Technical Service Bulletin

Date: 2012-07-19 **SAP DIR #: 20012762**

Subject: TSB -CP100-200 PATTERN 9 PCBA and GATE 7

Product(s) Referenced: CP100 and CP200 Electrocardiographs

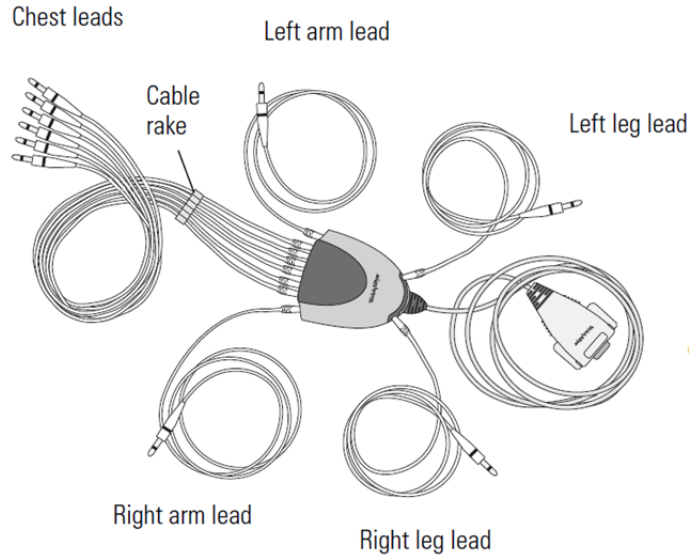
There are three states of the LED: GREEN, YELLOW and not illuminated. The LED is GREEN to indicate AC mains power is connected. The LED is YELLOW to indicate the battery needs to be charged or replaced. The GREEN LED takes precedence over the YELLOW LED. The LED will be GREEN when connected to a live mains voltage source. The LED can only be YELLOW or not illuminated when operating from the battery.

The LED will be YELLOW when the CP100-200 is operating on battery power and the cell voltage decreases to ~5.6V. Once initiated, the LED shall remain YELLOW until the cell voltage increases to ~6.3V (indicates a charge condition) or returns to green any time AC mains is connected. The LED will revert to YELLOW if AC mains is disconnected before the battery voltage increases to ~6.3V (indicates a sufficient charge has not taken place).

The Yellow LED will only be visible with this combination: The Pattern 9 PCBA and new Keyboards 405641 or 403312.

Note: When the device begins to print it will cause a sudden drop in measured voltage below ~5.6V but then rebound back to its previous level. This sudden drop and rebound will cause a brief flash of the LED (yellow) if the device is on battery power.

Nieuwpoort module redesign:

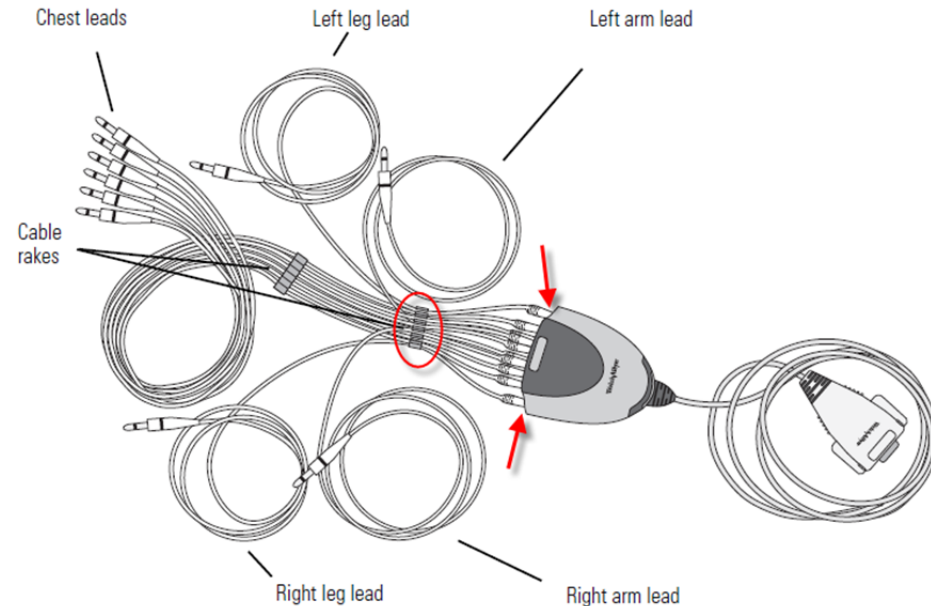
- The Nieuwpoort module (a.k.a. Patient Cable) has been redesigned moving the lead wire connections for RL and LL to the front of the module along-side all other lead wires. An additional Cable Rake has been added close to the Nieuwpoort to reduce susceptibility to noise:

Previous configuration:

New Configuration:

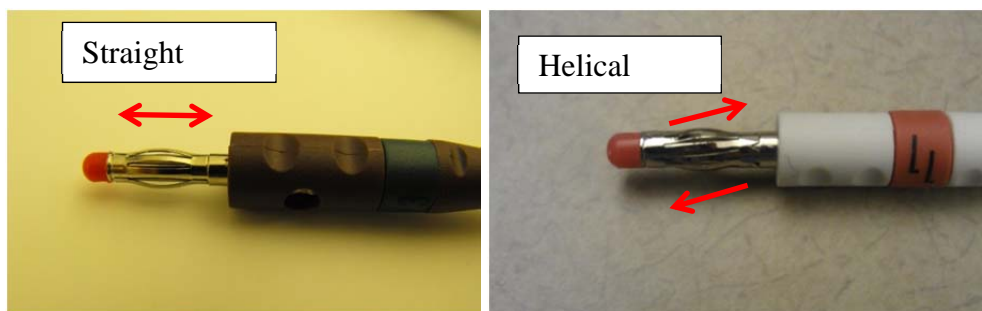
- Lead wires now inserted prior to shipment:
Welch Allyn Manufacturing will insert the banana contact lead wires into the Nieuwpoort so that the end customer will not need to perform this assembly.
- Replacement Patient cable to include lead wires already inserted:

To ensure that customers will always receive new lead wires whenever replacing the Patient Cable (Nieuwpoort), the existing Bill of Materials has been changed to include the banana contact lead wires which will be pre-assembled as mentioned above.

- The List price of the Patient Cable will not change with the addition of the lead wires.
- The customer facing Patient Cable part numbers (400293 AHA and 400294 IEC) remain the same (WA internal material number 408826 / 408661 replaces 401126 and 408827 / 408662 replaces 401127)
- The customer can still order the 10-lead replaceable lead sets separately if needed.
